SEWAGE DISPOSAL SYSTEM

DEPARTMENT OF HEALTH AND MENTAL HYGIENE

P 56641
A REPAIR
DISTRICT _____
DATE 5-21-96
DATE SYSTEM APPROVED 5/22/96
INSPECTOR gg

L & F Company - Sam Lyons IS PERMITTED TO INSTALL _____ ALTER X
ADDRESS 10688 Scaggsville Road, Scaggsville, MD 20707 PHONE 725-3392
SUBDIVISION _____ LOT _____ ROAD 12049 Scaggsville Road
PROPERTY OWNER D.W. Brown
ADDRESS _____

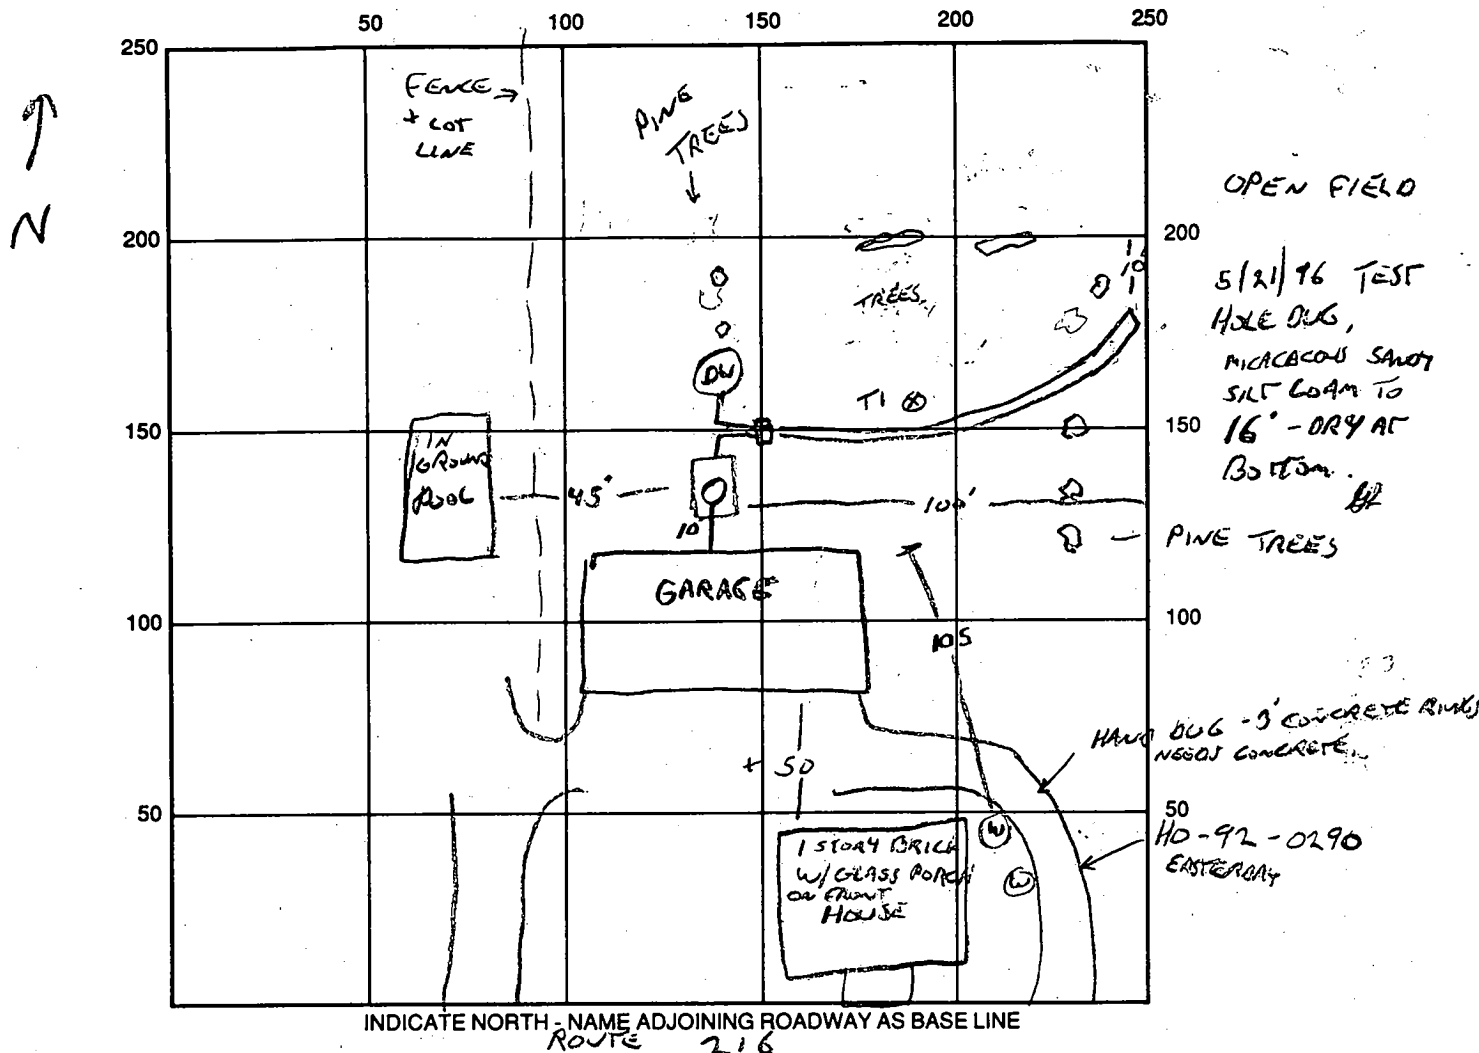
SEPTIC TANK CAPACITY NA GALLONS → EXISTING SEPTIC TANK APPEARS TO BE IN GOOD
NUMBER OF BEDROOMS 2 SHAPE,
125 SQUARE FEET PER BEDROOM NOTE: SHELF TRENCH WALLS TO PROVIDE
LINEAR FEET OF TRENCH REQUIRED 100' SAFE WORKING AREA IF TRENCH
BOX NOT USED. - SOIL UNSTABLE.

REPAIR - PURPOSE - SEPTIC SYSTEM HAS FAILED.
Call for inspection when ground is opened so sanitarian can recommend repairs.

TRENCH TO BE 3' WIDE, INLET AT 9' BOTTOM AT 11'
2' STONE BELOW DIST. PIPE. INSTALL DISTRIBUTION BOX
BETWEEN TANK AND DRYWELL, CONNECT DRYWELL WITH FLOW
RESTRICTOR LIMITING FLOW TO WHEN TRENCH IS FULL

SEPTIC TANK LEVEL NA CLEANOUTS NA
 DISTRIBUTION BOX LEVEL OK - RESTRICTOR TO BE ADDED
 DRAIN FIELD/TITLE DEPTH 11 FT. TRENCH WIDTH 3 FT. INLET DEPTH 9 FT.
 EFFECTIVE GRAVEL DEPTH 2 FT. TOTAL LENGTH 105 FT.
 NUMBER OF TRENCHES 1 ONE SIDEWALL/BOTTOM AREA 315 SQ. FT.
 DRYWALL INSIDE DIAMETER - FT. EFFECTIVE DEPTH BELOW INLET - FT.
 ABSORBENT AREA - SQ. FT.

REMARKS: 5/20/96 CONTRACTOR REPORTS DRYWELL FULL, TOP OF TANK IS 7' BELOW GRADE. SEPTIC SYSTEM IS ABOUT 40 YEARS OLD. DRYWELL NOT OPEN AT TIME OF INSPECTION. REPAIR PERC TO BE DUG AS DEEP AS POSSIBLE.
5/22/96 DIST BOX IN, TRENCH STARTED OK TO CONTINUE. PM - TRENCH CIVIL/MS OK TO COVER SYSTEM. DRYWELL CLEANOUT BROKEN - CONTRACTOR WILL ATTEMPT TO REPAIR AND NOTIFY US OF RESULTS.
